## Proposal for a Corrigendum to the Revision 7 and Revision 8 to UN Regulations No. 13

*Figure 1B, correct to read:*

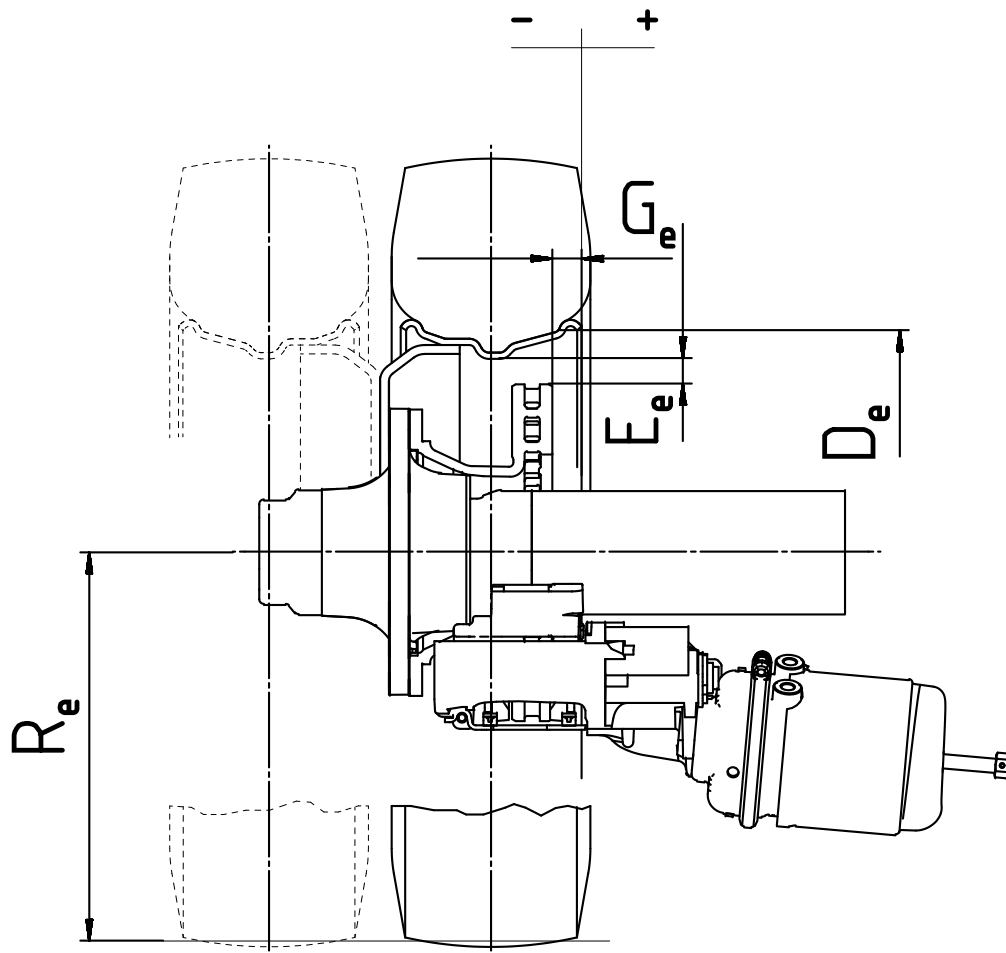
Revision 7 of Regulation No. 13 includes a former version of Figure 1B which was changed with Amend 4 to Revision 6 of UN Regulation No. 13. This correction is also needed for Revision 8, which contains the same error.
